Re: Notice of Proposed Action to Building Standards of the
Department of Housing and Community Development
Regarding the 2013 California Building Code
California Code of Regulations, Title 24, Part 2, Chapter 11
"Housing Accessibility"

Subj: Public Comment Period

FIGURE 11A-10A
KITCHEN SPECIFICATIONS

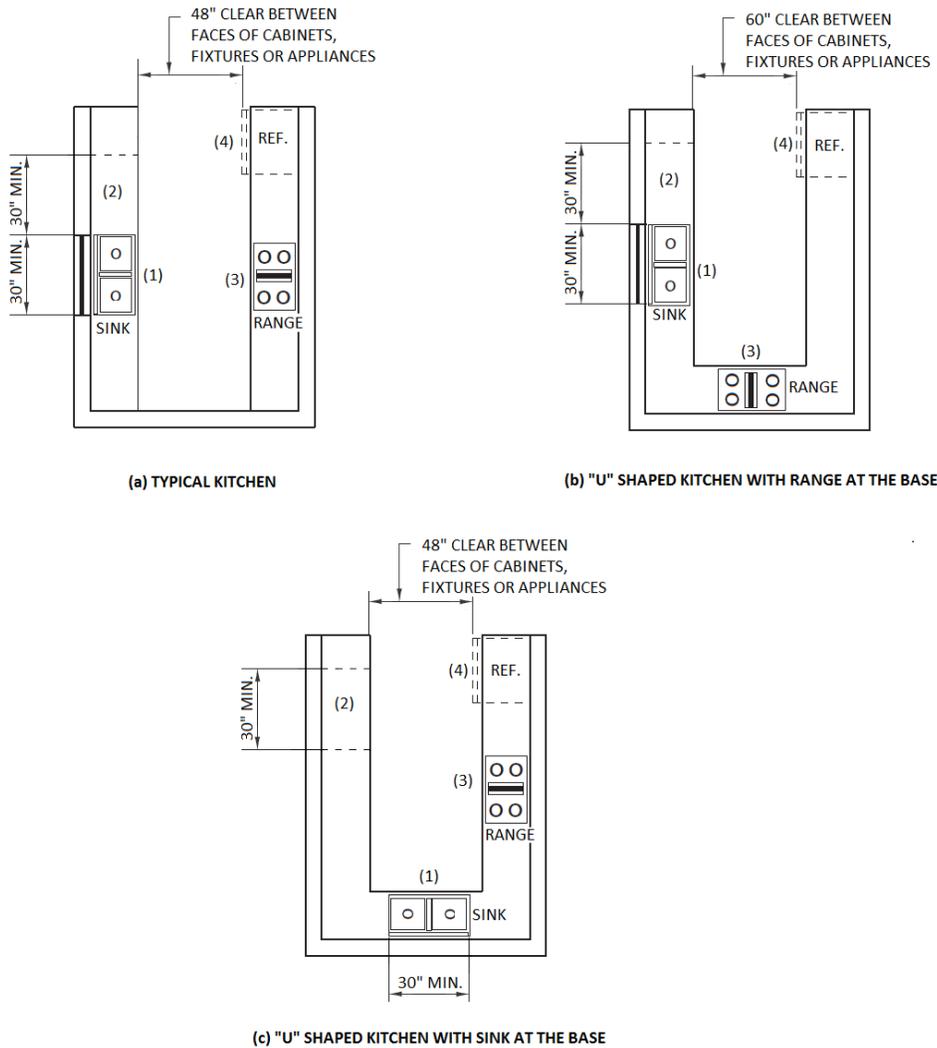
Recommendation: Revise clear width dimensions at kitchens to align with text in section 1133A.2.1 that identifies clear width as 48" minimum and 60" minimum. Dimensions in illustrations do not state "minimum" and should be revised to say:

"Minimum 48" clear between faces of cabinets, fixtures, or appliances"

"Minimum 60" clear between faces of cabinets, fixtures, or appliances"
